GOODWAY LTD		MODEL NAME pony	PROJECT NO B5187	DOCUMENT TYPE Protel99	
DESCRIPTION Ponies Stable --Main Board				DOC. REVVer0.4	
DOCUMENT NO	SC-FEB5187-A-001			SIZE A4	SHEET 1 of 2
CORRESPONDING PCB P/N	M4P-FEB5187MB-04/TB-07/IB-00				
FILE NAME	PM4P-FEB5187MB/TB/IB-002				
DESIGNED BY:	DRAWN BY: lth	CHECKED BY:		APPROVED BY:	
DATE:	DATE: 2003/05/23	DATE:		DATE:

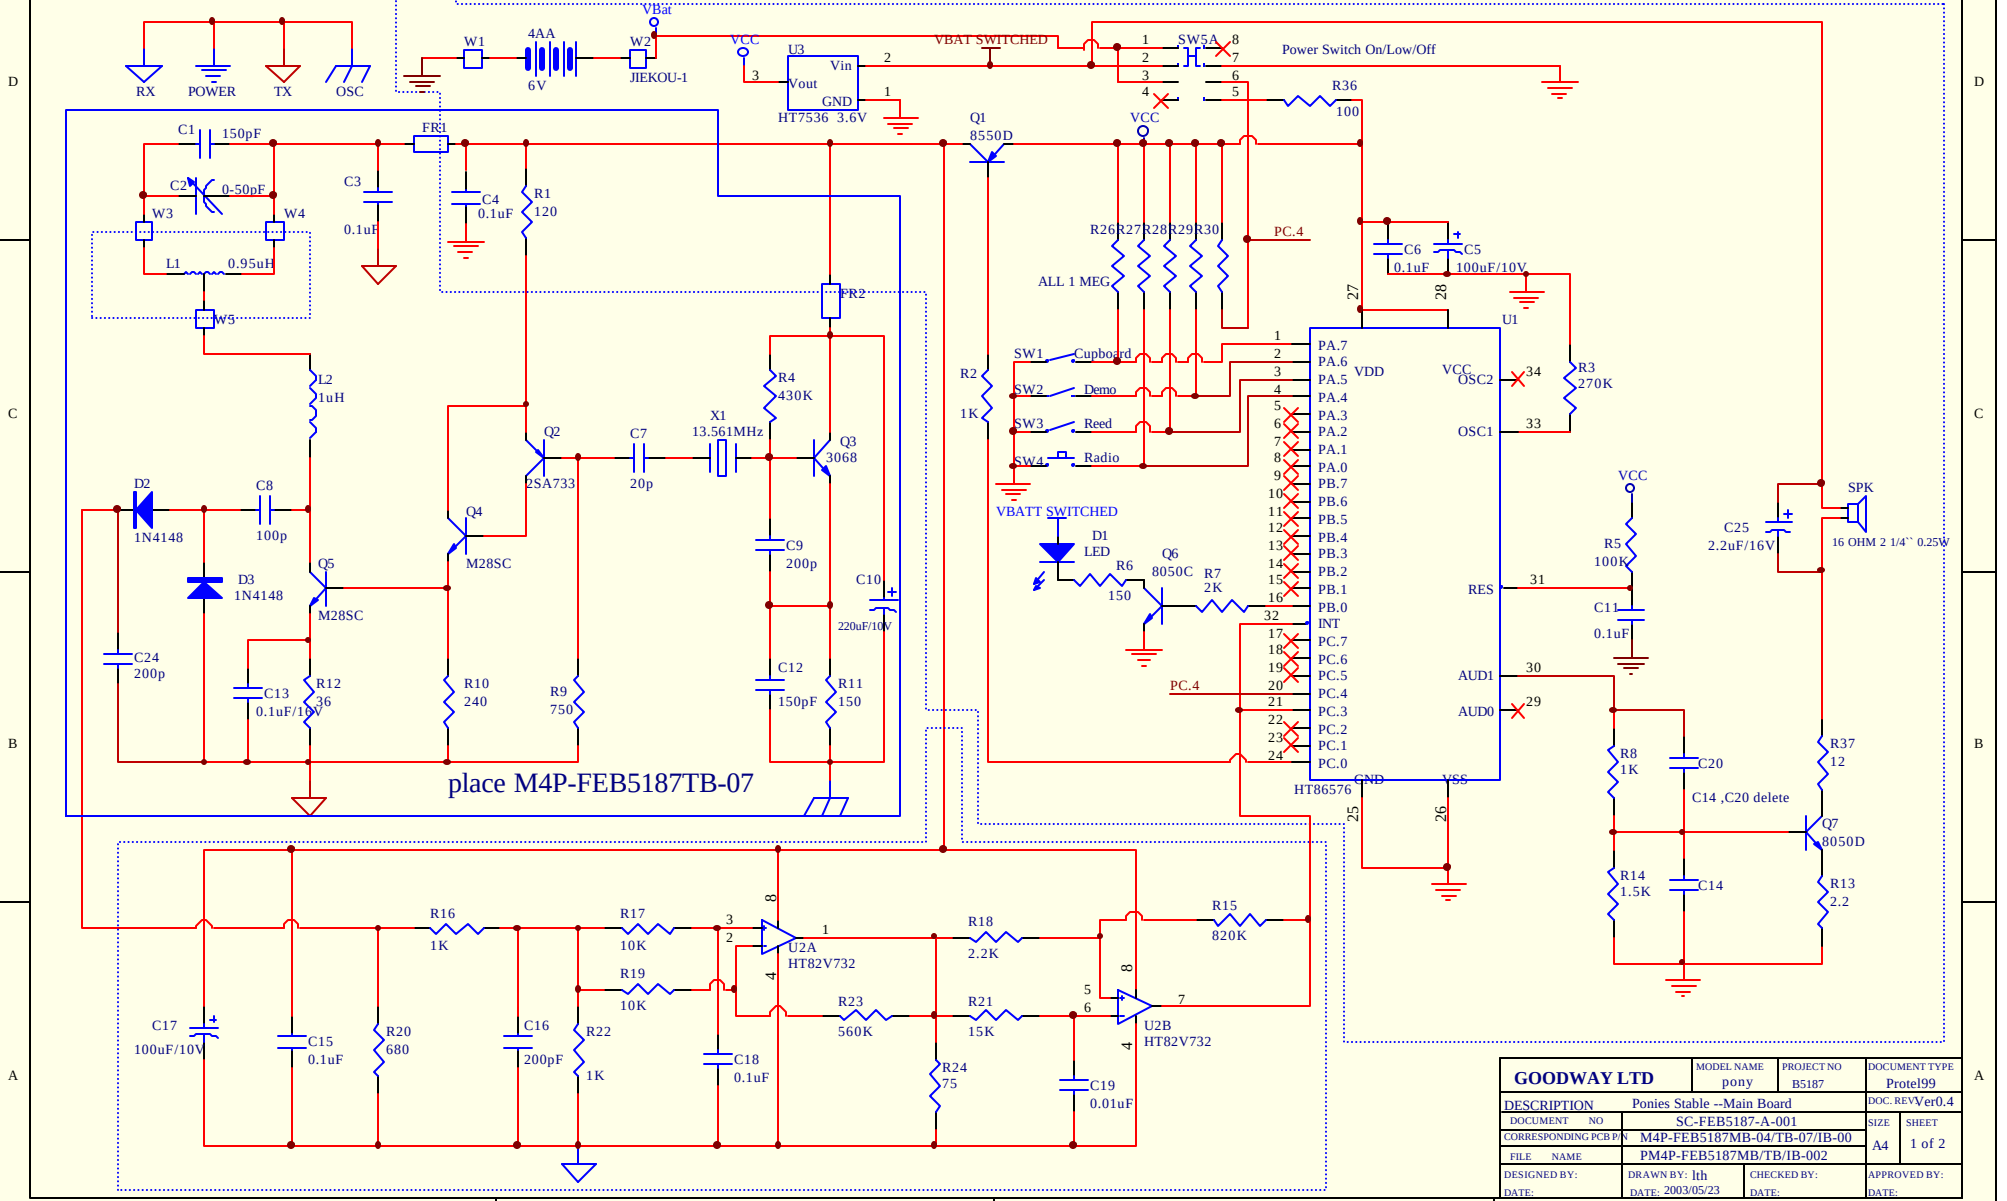
REV	DESCRIPTION	PROJ/STAGE	CHANGE/B	APPROVE/B	EFFECT DATE
02	Change R21=2.2K to 10K; R8=1k to 820; R14=750 to 680; C20=0.1uF to 0.22uF; C14=1uF to 0.1uF; C1=180 to 150PF; C9=18 to 200PF; C12=68 to 150PF; R4=430K to 200K; L2=1.2uH to 1uH; A1	FER37=12	lth	lth	
03	ADD R13=2.2, C25=2.2uF, C24=200PF, Del FR3, C23=100PF, R35=100K, C14=0.1uF, C20=0.22uF, R21=10K to 15K, R4=200K to 430K, R3=100K to 270K, R8=1K, R14=1.5K, R6=150.	FEP	lth	lth
